RE: MAIN AVENUE STREET IMPROVEMENTS, MAIN AVENUE STORM SEWER
 IMPROVEMENTS AND WASTEWATER COLLECTION SYSTEM
 IMPROVEMENTS
 PRESHO, SOUTH DAKOTA
 SPN #14740 – SRF#C461236-01
 CDBG#1718-103 – DOT#CA 018J PCN 06MY

ADDENDUM NUMBER 2

DETAIL: 334100-01

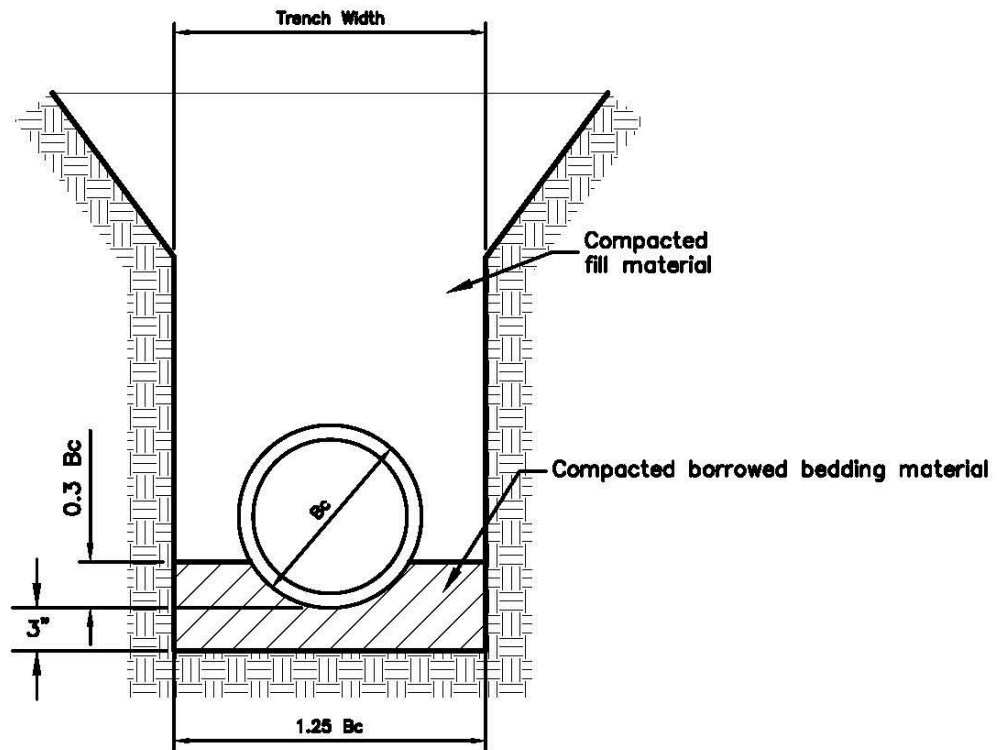
Bedding of RCP Storm Sewer shall be as shown on Detail 33 41 00-01 attached to this addendum.

Bedding of RCP Storm Sewer shall be as shown on Detail 334100-01 attached to this addendum.

DETAIL: 334100-02

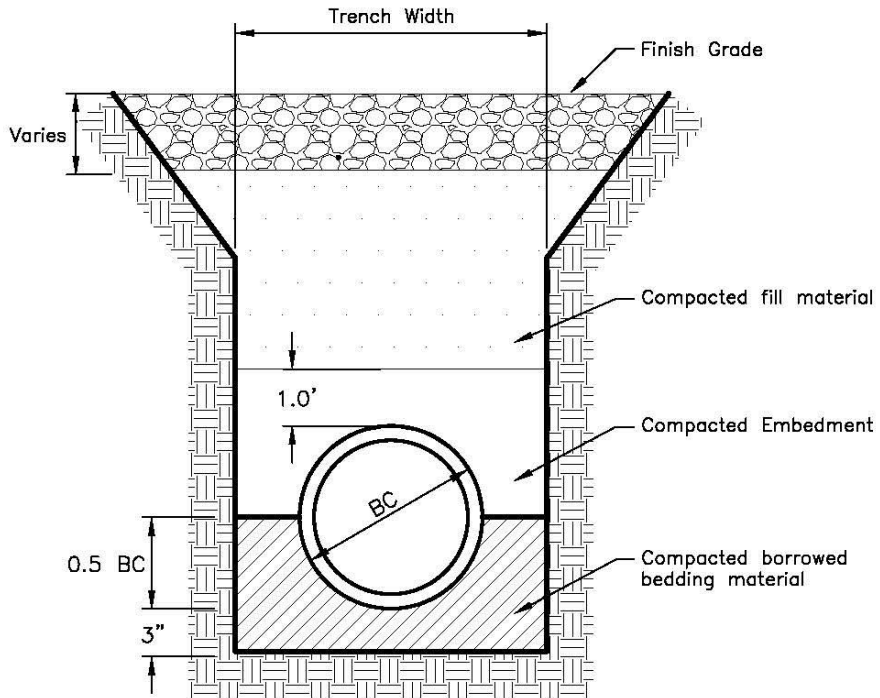
Bedding of PVC Storm Sewer shall be as shown on Detail 33 41 00-02 attached to this addendum.

Bedding of PVC Storm Sewer shall be as shown on Detail 334100-02 attached to this addendum.

NOTE: Compacted Embedment shall be finely divided job excavated materials (<3" Diameter) placed in uniform layers not more than 8" thick and compacted to 95% maximum density s determined by ASTM D698.
